**RE:** File No. 6676 – Concord Lane and New Street Sewer and Pump Improvements  
Project - Addendum No. 1

CITY OF CAMBRIDGE, MASSACHUSETTS  
SPECIFICATIONS  
FOR CONCORD LANE SEWER SEPARATION AND NEW STREET SEWER AND PUMP  
STATION IMPROVEMENTS PROJECT

**ADDENDUM NO. 1**

JANUARY 8, 2015

ELECTRICAL VAULT AND SUMP DETAIL

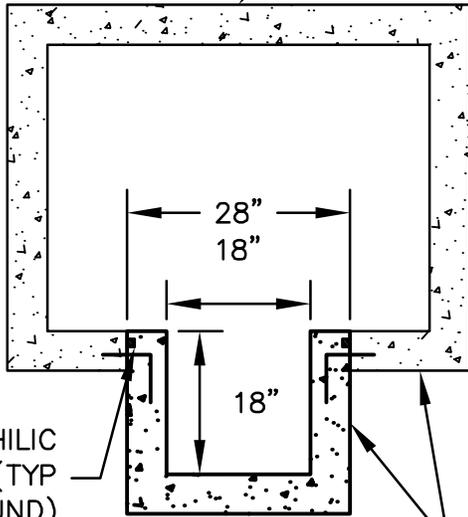
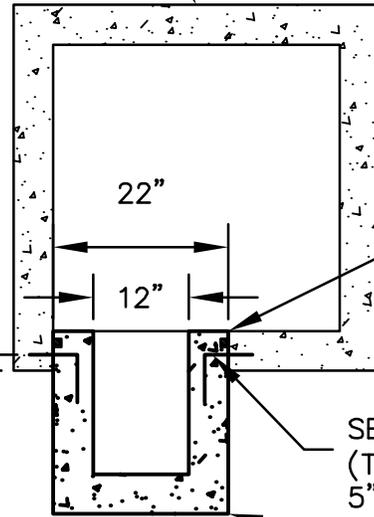
3. **SHEET GC-9: Edits will be included in the Conformed Set.**
  - a. **DELETE** details 31, 32, 33, 34, and 35.
  - b. **ADD** detail (**SK-ADD1**) for “Electrical Vault and Sump Detail.” (**8.5”x11” detail reissued as part of addendum**)

LOAM AND SEED  
 NEW STREET

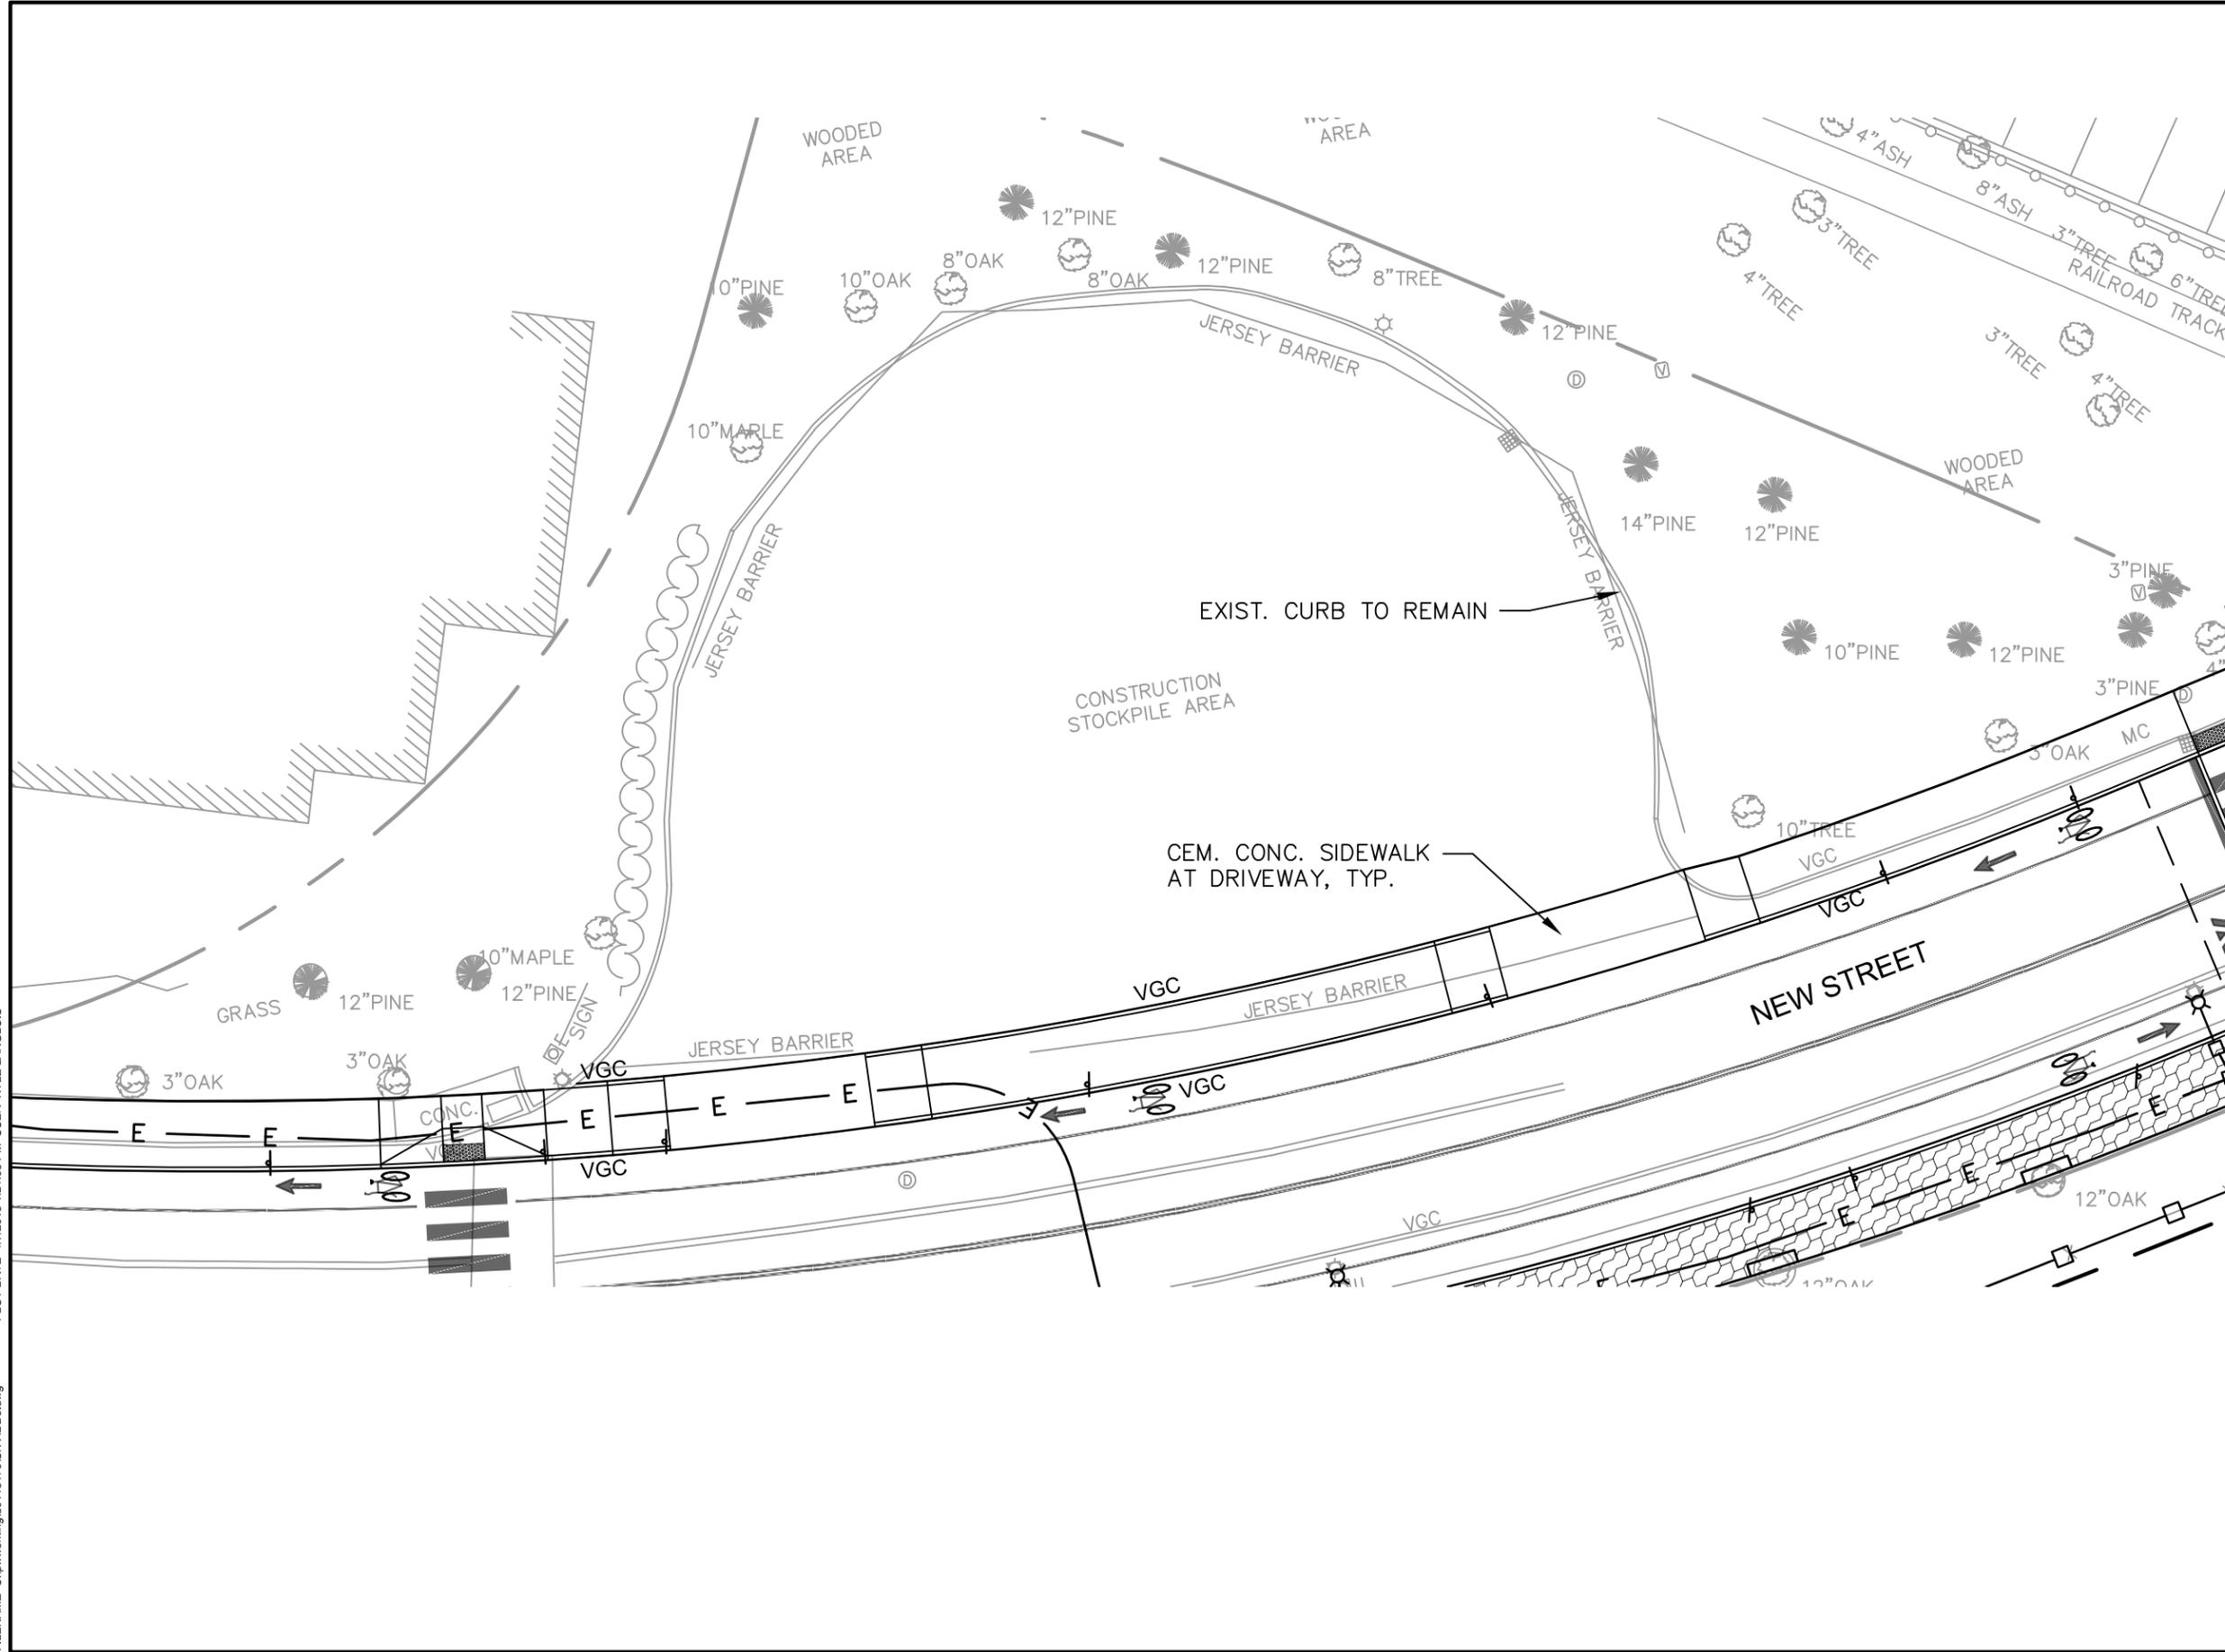
- a. **MODIFY** text “FULL DEPTH RECONSTRUCTION” to “PAVEMENT RECLAMATION”.
- b. **MODIFY** text “REMOVE & REPLACE EXIST. 6’ ORNAMENTAL FENCE IN-KIND” to “REMOVE & REPLACE EXIST. 6’ ORNAMENTAL FENCE W/6’ BLACK VINYL COATED CHAIN LINK FENCE”.
- c. **MODIFY** text “TYPICAL SECTION A” to “TYPICAL SECTION B”.
- d. **MODIFY** text “TYPICAL SECTION B” to “TYPICAL SECTION C”.
- e. **ADD SK-ADD2 (attached to this Addendum)**, which includes a hydrant relocation and bollard removal near 52 New Street.
- f. **MODIFY** text ‘EXIST. CONC. SLAB APPROX. 18”-24” BELOW GRADE, CONC. IS ASSUMED TO BE 8”-12”’ to ‘EXIST. CONC. SUB-GRADE APPROX. 10”-18” BELOW GRADE.’ for “TYPICAL SECTION B” and “TYPICAL SECTION C”.
- g. **ADD SK-ADD3 (attached to this Addendum)**, which includes revisions of seeded lawn and planting soil limits near 83 New Street.

Figure  
3

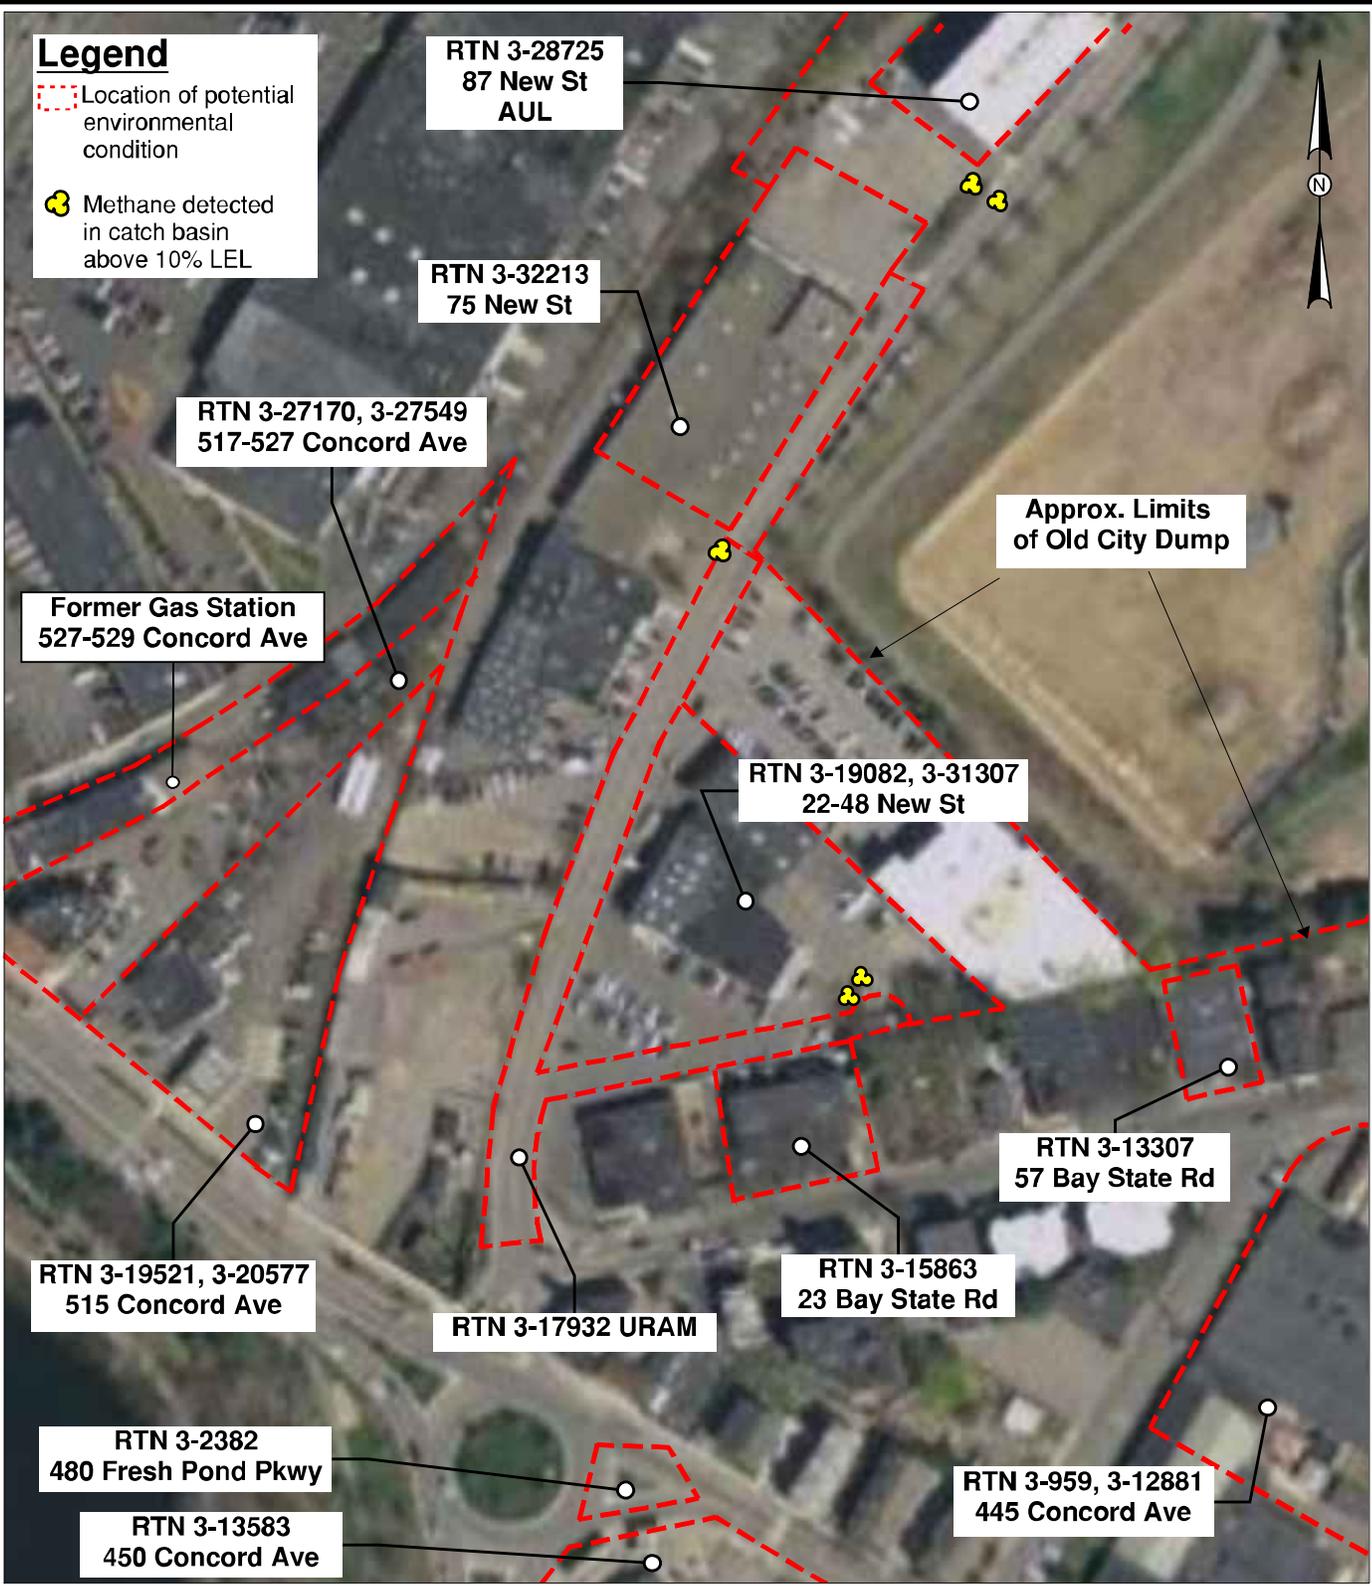
- a. **MODIFY** section 1.8 F on page to:  
Page 6. References to Table 3 should be changed to Table 2.
- b. **MODIFY** Table 1. Sample ENV3 0.5-8: TCLP lead concentration result should be changed from NT to .0547. **Corrected table is attached.**
- c. **ADD** Table 2.(**attached**) Groundwater data  
Appendix B: Analytical package 14K0452 should be moved to Appendix A
- d. The following changes should be made to the New Street Environmental Summary Memo dated 12/5/14:  
**MODIFY** Figure 3: to the **attached "Figure 3 rev"**
